APRIL 24 1979

Dockets Nos. 50-317  
and 50-318

The Commission has issued the enclosed Amendments Nos. 38 and 21 to Facility Operating Licenses Nos. DPR-53 and DPR-69 for the Calvert Cliffs Nuclear Power Plant, Units Nos. 1 & 2 (CCNPP-1/2). The amendments consist of changes to the Appendix A and B Technical Specifications (TS) in response to your applications dated November 13, 1978 and January 31, 1979.

Amendment No. 38  
License No. DPR-53

**FIGURE 3.1-1**  
**Minimum Boric Acid Storage Tank Volume and Temperature**  
**as a Function of Stored Boric Acid Concentration**

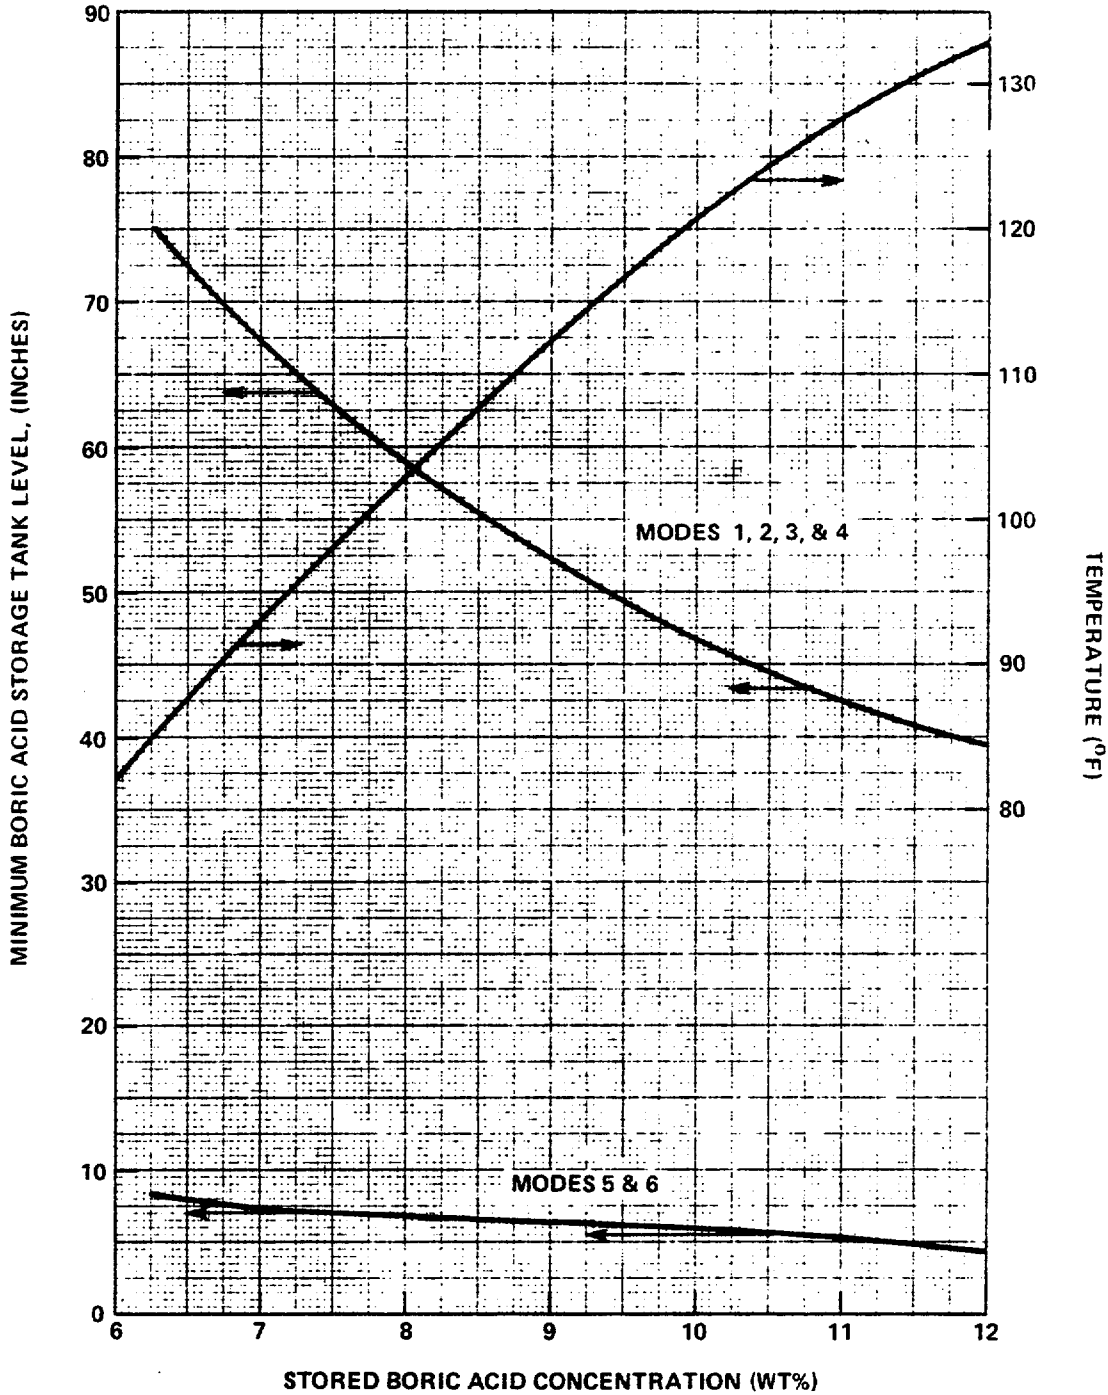
- a. Two boric acid storage tank(s) and one associated heat tracing circuit per tank with the contents of the tanks in accordance with Figure 3.1-1 and the boron concentration limited to  $\leq 8\%$ , and
- b. The refueling water tank with:
  1. A minimum contained borated water volume of 400,000 gallons,
  2. A boron concentration of between 1720 and 2200 ppm,
  3. A minimum solution temperature of 40°F, and
  4. A maximum solution temperature of 100°F in MODE 1.

FIGURE 6.2-1  
 Management Organization Chart  
 Calvert Cliffs Nuclear Power Plant  
 Baltimore Gas & Electric Company

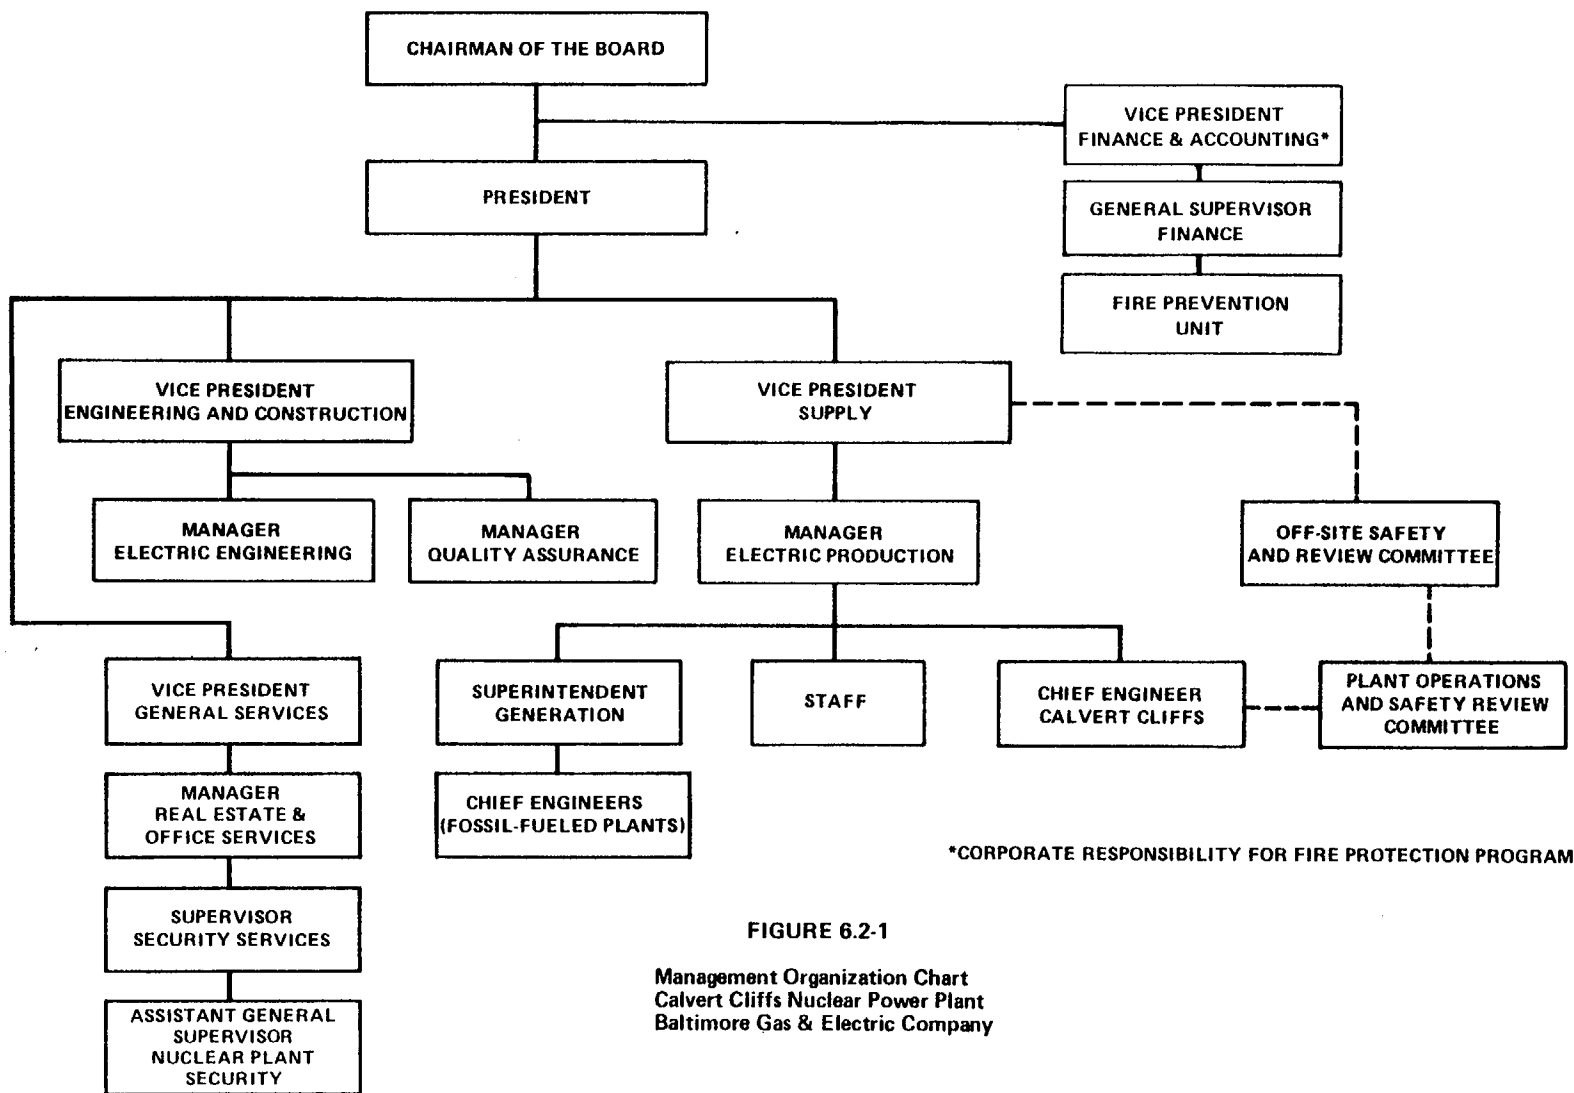
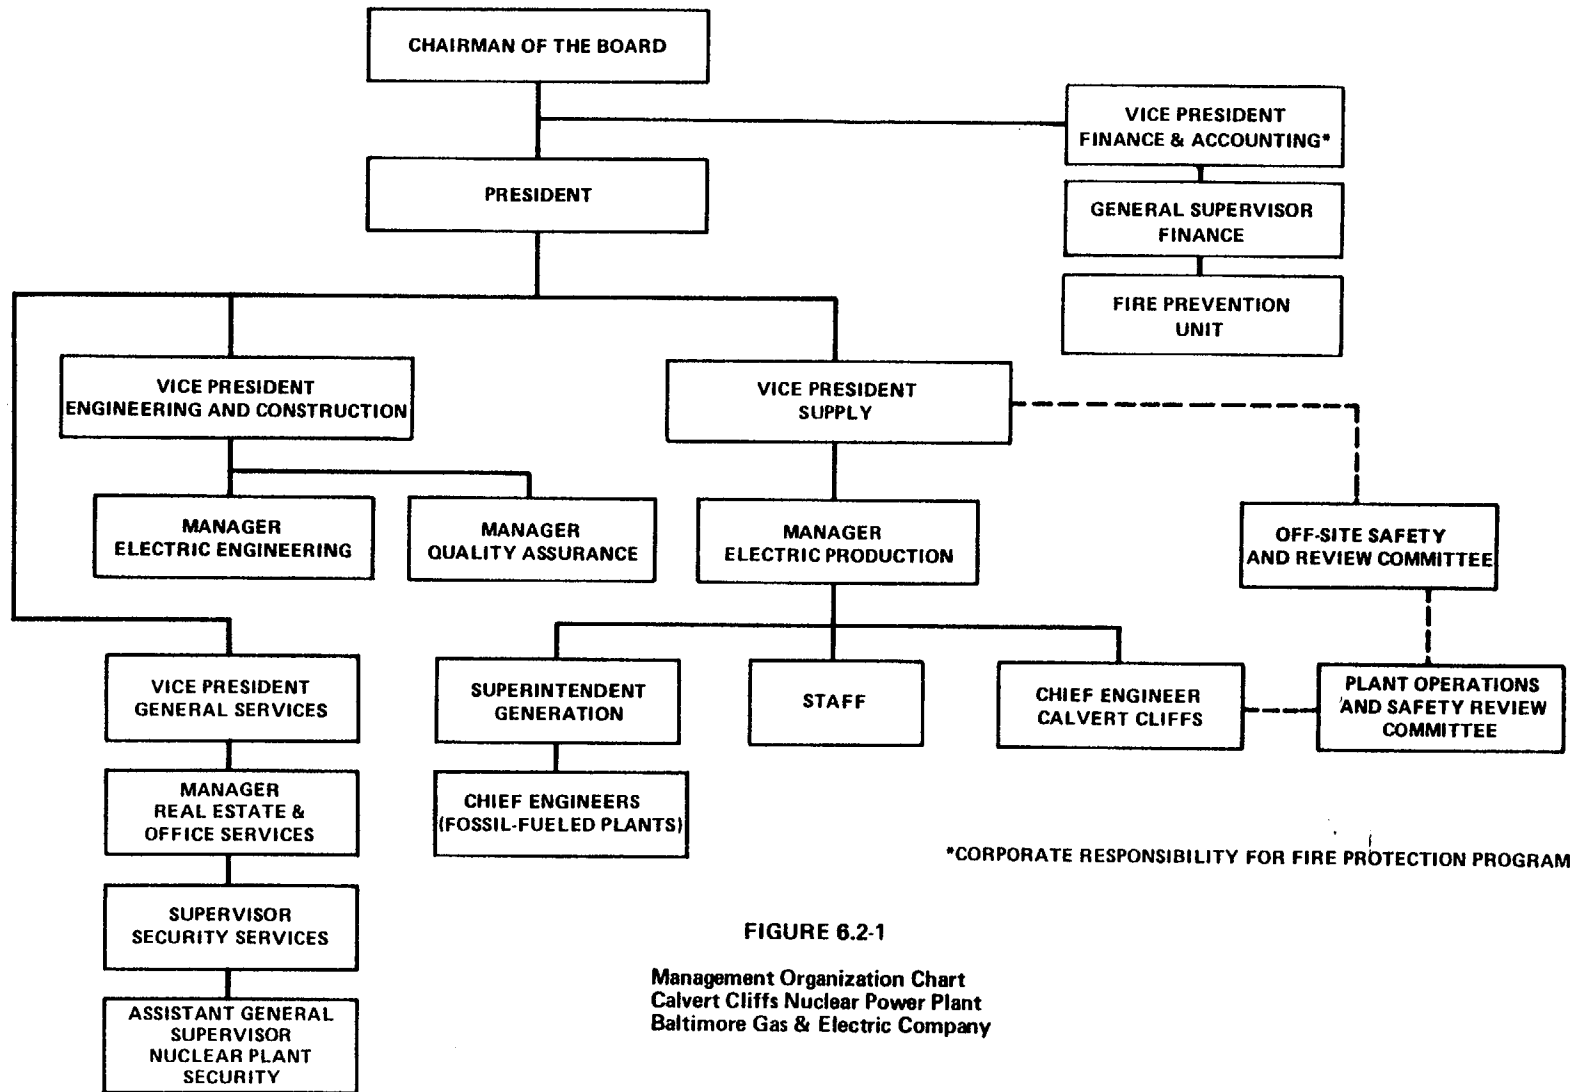
BG&E has recently placed the CCNPP security force under the cognizance of the Real Estate and Office Services Department. This is consistent with other BG&E security functions. Proposed change No. 10 of the November 13, 1978 letter reflects this organizational modification. The proposed title of one of the positions needs to be modified to agree with the title documented by the BG&E security submittal. BG&E has agreed to this change in title.

We find this change continues to provide adequate separation between the security organization and the plant operating staff. Therefore, we conclude that the proposed change in security force organization is acceptable.

**FIGURE 3.1-1**  
**Minimum Boric Acid Storage Tank Volume and Temperature**  
**as a Function of Stored Boric Acid Concentration**

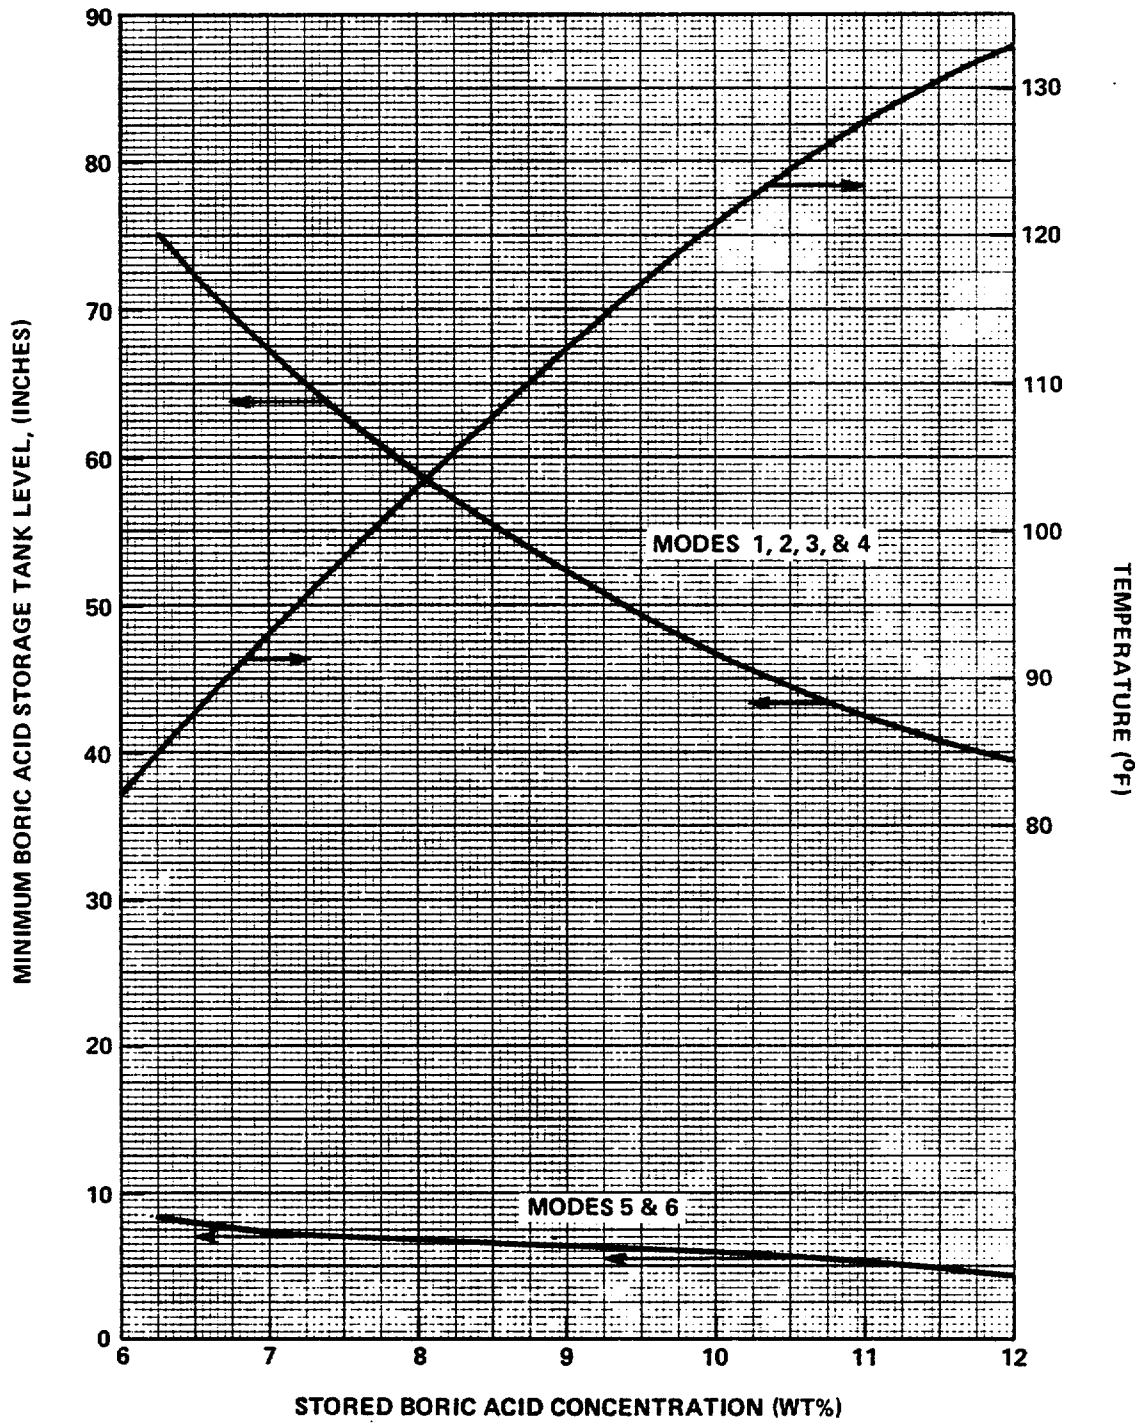
- a. Two boric acid storage tank(s) and one associated heat tracing circuit per tank with the contents of the tanks in accordance with Figure 3.1-1 and the boron concentration limited to  $\leq 8\%$ , and
- b. The refueling water tank with:
  1. A minimum contained borated water volume of 400,000 gallons,
  2. A boron concentration of between 1720 and 2200 ppm,
  3. A minimum solution temperature of 40°F, and
  4. A maximum solution temperature of 100°F in MODE 1.
